IMPORTANT SAFETY NOTICE

Dear Specialized Rider:

Fig. 1: Quick-release lever with potential for contact

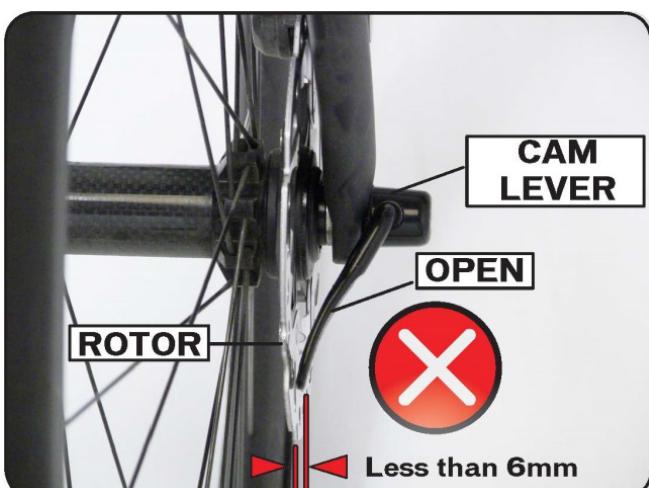
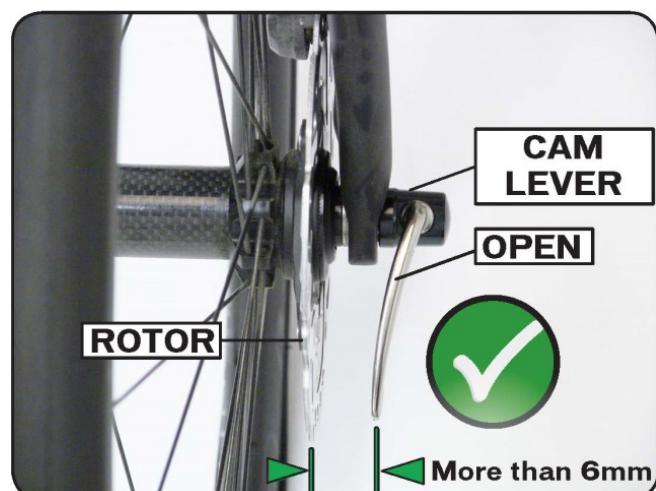
Some Specialized bicycles were sold equipped with disc brakes and a front quick release lever that can come into contact with the front disc brake when left open. An example of a bicycle with a front quick-release cam lever that is able to be opened far enough to create this potential contact is shown in Figure 1 below. An example of a bicycle with a front quick-release cam lever that does not have the potential for contact with the disc brake is shown in Figure 2. When a quick release like the one shown in Figure 1 is improperly adjusted or left open on a bicycle which also has a front disc brake, the quick release lever can become caught in the front disc brake assembly. If this happens, the front wheel could separate or come to a sudden stop and the rider could lose control of the bicycle posing a serious risk of injury.

Affected Models: Any Specialized bicycle equipped with disc brakes and a front quick release lever that can contact the disc brake assembly when fully opened is subject to this recall. Bicycles with front quick-release cam levers that have a clearance of at least 6 millimeters, which is the width of a #2 pencil, between the edge of the lever in its most open position and the disc brake rotor are not considered affected models. If you can pass a #2 pencil between a fully opened quick release lever and your bike's disc brake rotor, your bike is not an affected model. For more information on how to check this, please visit www.quickreleaserecall.com.

What Specialized will do for owners of a recalled bicycle: If you own a bicycle that is subject to this recall, Specialized will provide you—through your Authorized Specialized Retailer—a free replacement quick release, including free installation. We realize this issue will mean time off your bike and pose an inconvenience. In appreciation for your valuable time, Specialized and your Authorized Specialized Retailer will offer you a gift (approximately US\$20 value). Please see your local Authorized Specialized Retailer or contact Specialized Rider Care at 800-722-4423.
